Responses to referees' comments about the manuscript
"Multivariate bias adjustment of high-dimensional climate simulations: The "Rank
Resampling for Distributions and Dependences" (R2D2) Bias Correction"
by Mathieu Vrac

Anonymous Referee #1

Figure: Inter-variable Spearman correlation maps in winter over the evaluation period (1995-2009) from: (a) SAFRAN; (b) WRF; (c) 1d-BC (CDF-t); (d) 3012d-R²D².

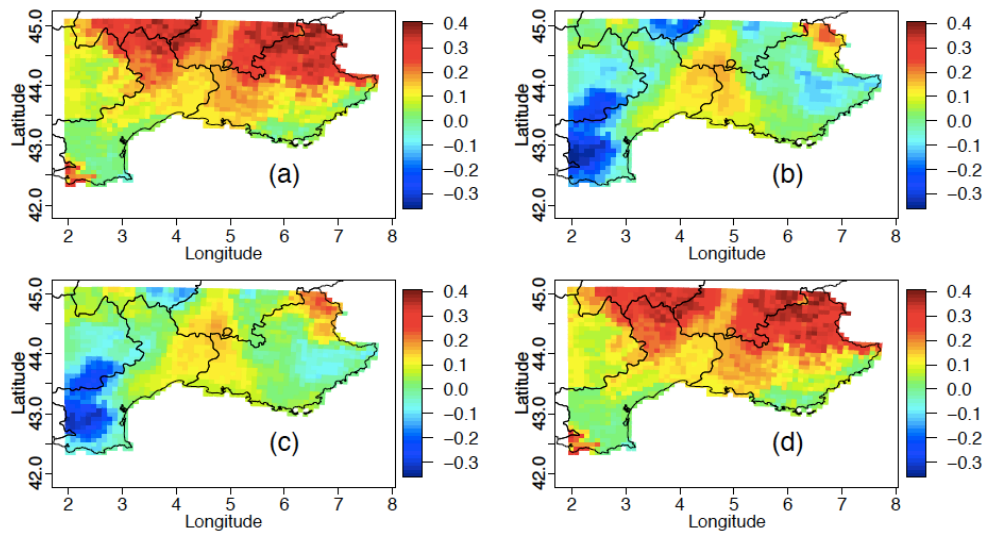
The author tests R2D2 on ERA-interim vs SAFRAN. These are both reanalysis datasets. This may be very interesting per se but is it really a good measure of how R2D2 will perform when applied to RCM data vs reanalysis or observations? I understand that the author does apply the new BC methodology to RCM data but not in a cross validation setting. I would like to understand why he has chosen not to apply R2D2 to RCM data, using SAFRAN as observations, calibrating with one part of the reanalysis data while cross-validating using another. Much like he did with ERA-Interim. In other words, why was ERA-Interim used at all? I find the tests using reanalysis data encouraging to be sure but not as satisfying as a test with RCM data would have been.

However, the question of the cross-validation for the correction of the RCM simulations is highly relevant. Consequently, the same cross-validation framework as for ERA-I data has also been applied to RCM simulations. For illustration, the inter-variable Spearman correlation maps are presented in the figure below, showing the reference SAFRAN correlations (panel a), those from WRF (b), from the

1d-BC data (c) and finally from the 3012d-R²D² (d), both calculated over the “evaluation” period (1995-2009) with a calibration on 1980-1994.

It is clear that the conclusions are exactly the same as those provided either without cross-validation with the RCMs, or with cross-validation with ERA-I: WRF inter-variable correlations (b) are quite different from SAFRAN’s; 1d-BC basically reproduce the WRF correlation maps; and R²D² (both in its 2d and 3012d-versions but only shown for 3012d here) is very close to the SAFRAN correlation map. This is also the case for the EOF analyses in temperature or precipitation performed on the R²D² bias corrected dataset with the same cross-validation. Those analyses display the good spatial behaviour of R2D2, i.e., with its first EOFs (in T2 or PR) very similar to those from SAFRAN, as illustrated in the two figures below.
